APPENDIX 8
DISPERSION MODELING FILES

CLASS II MODELING REPORT

ATTACHMENT 8A-2
RESPONSES TO BAPC MODELING REVIEW – APRIL 2007

Figure 8A-6. On-Site Data Wind Rose at 10-M Level

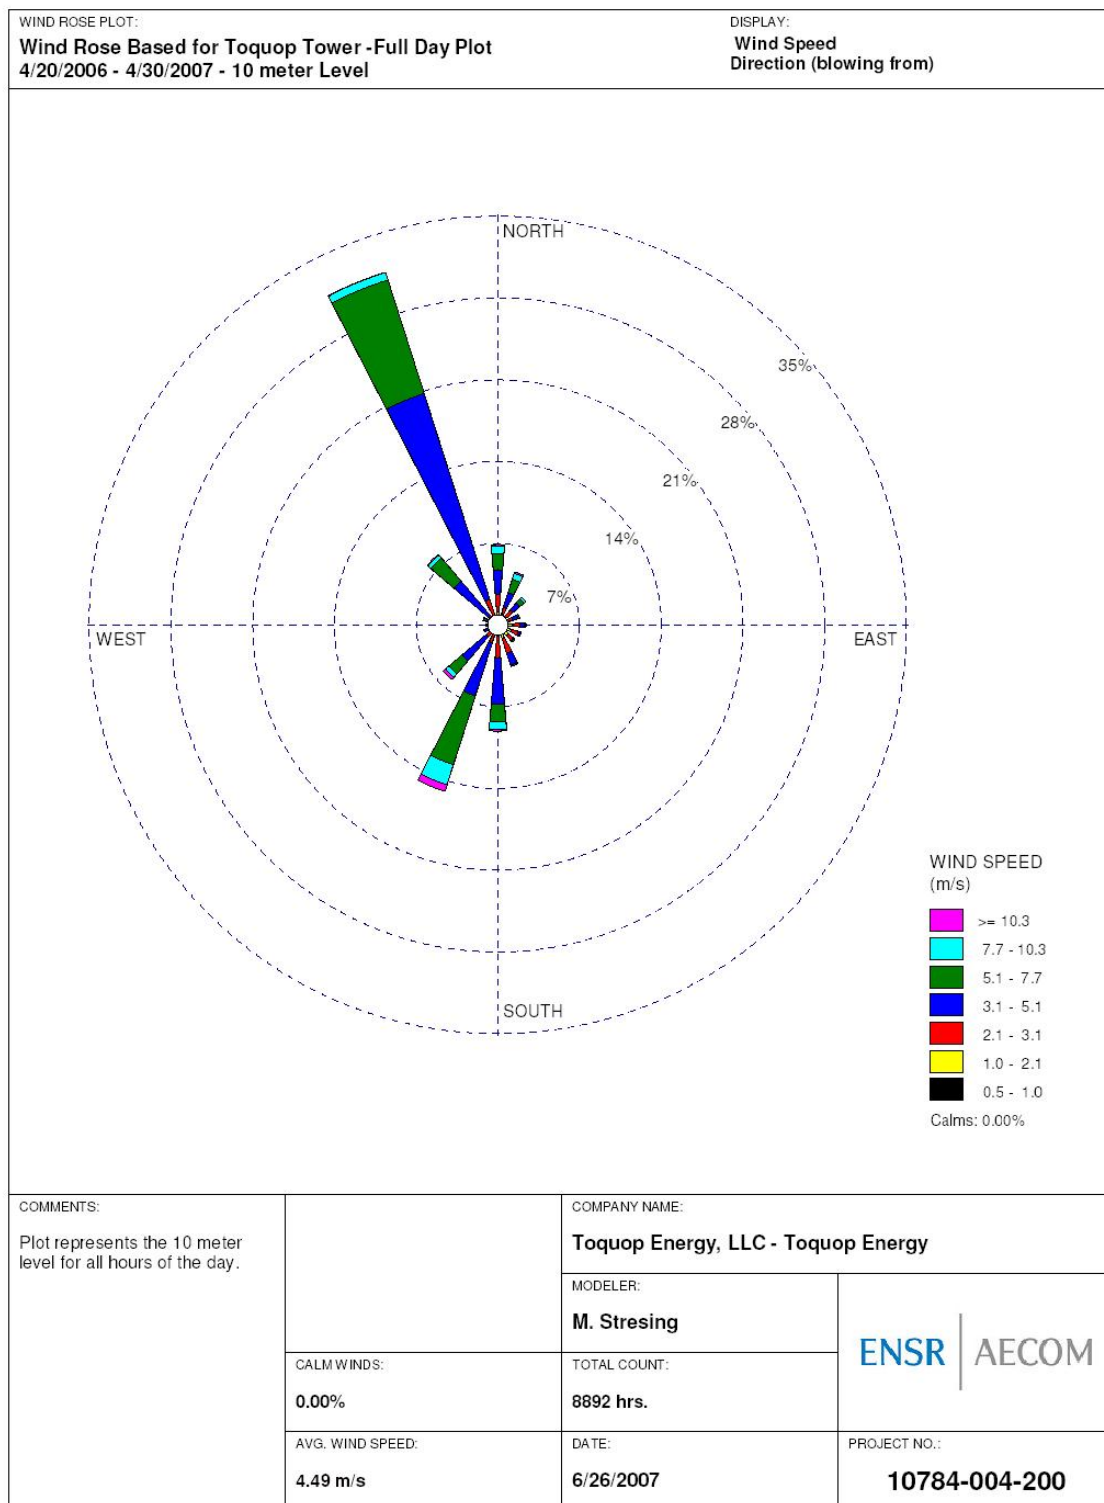
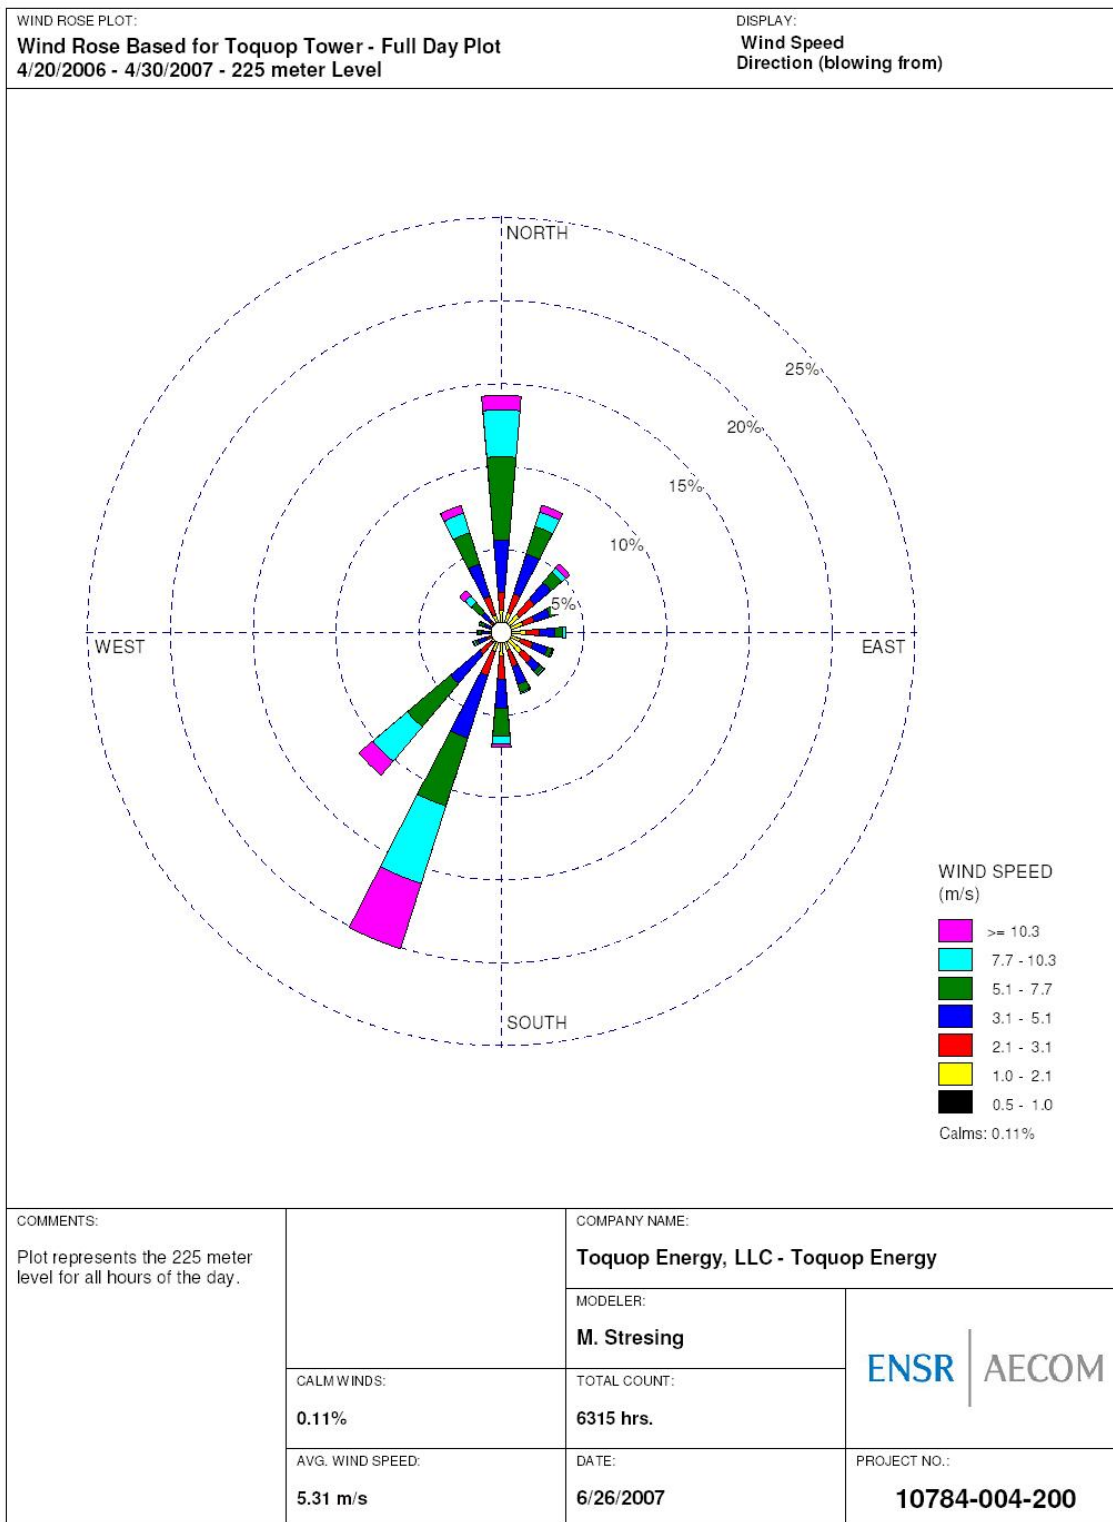
3. Section 3.2.3 Wind roses are provided at the 10-m and 200-m levels. Provide a wind rose at the 225-m level consistent with the top of the stack. Given the fact the 10-m capture rate is greater than 99% and the 200-m capture rate (based on the information provided on the wind rose plots) is approximately 75%, the statement that the low-level nocturnal drainage flow is absent at the 200m level is unfounded and cannot be supported by the data presented. This comment also applies to the discussion of wind patterns being influenced by the synoptic pattern and valley itself, made in section 3.2.2. The Data Period information presented on the wind rose plots needs to be corrected.

Response: *Additional levels for wind roses, including the 225-m level, are provided in the modeling report and archive to better characterize the wind characteristics as a function of height. The updated wind roses are provided for the entire year of monitoring, with the data period described labeled appropriately.*
